Design Review Committee

August 2, 2023

3376 East Main Street – Sukhwinder Singh, Jugaad, LLC - New Construction

Comments compiled by Lesa Ternet on 7/7/23

A204

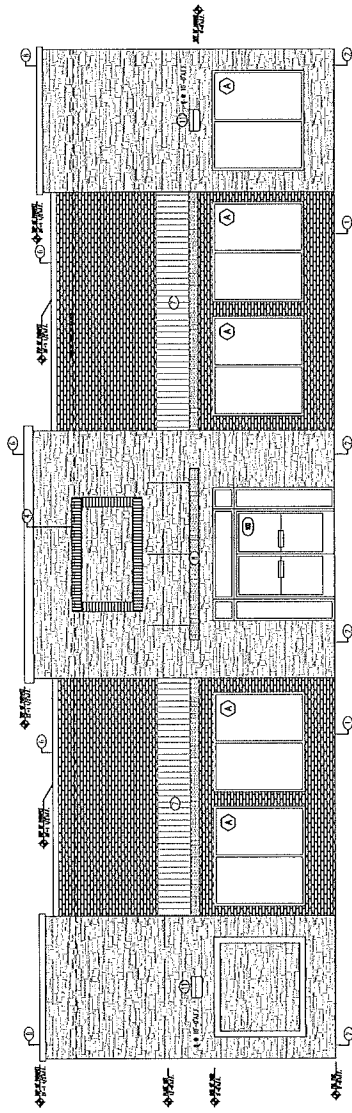
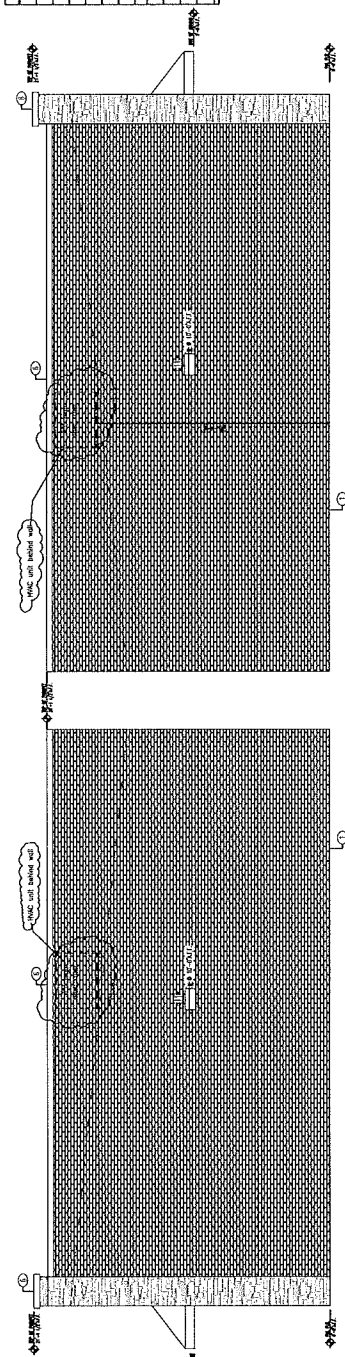
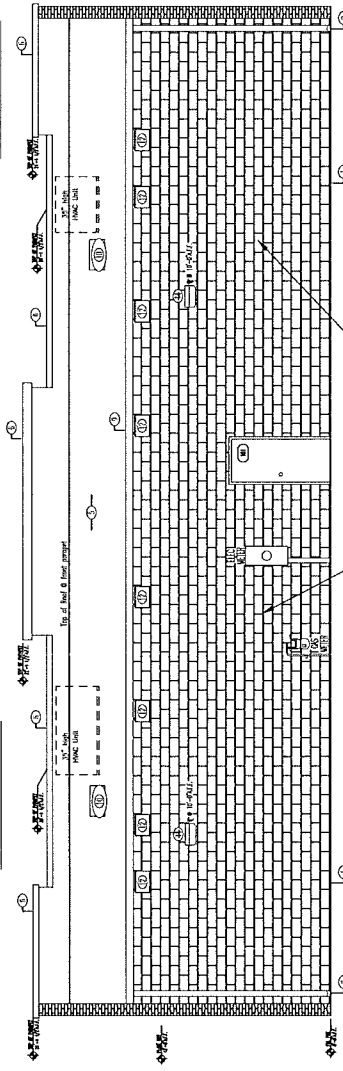
1. This set does not include a revised site plan.
2. The elevations on A401 do not match up with the floor plan on Sheet A201
3. Is the attached drawing the only thing that they have submitted regarding the Gas Island Canopies?

11. The building elevations and the floor plan need to match. **Answer: Changes have been made. See Pages A101, A201, A203.**

Main Entrance: their combination of fabric and metal awnings are odd. I'd prefer all one type or the other. **Answer: All canopies are now metal. See page A401.**

Very perceptive on your reviewer's part. I missed it. That window in the rear was removed from all the drawing pages, except the Elevation. There is NO window planned at that location in the office.

Danville Town Review. Remove top of parapet. Eliminate 2 windows. Show HVAC, Show HVAC unit on

Lighting details.
7/26/23. Remove window from rear (North) elevation.
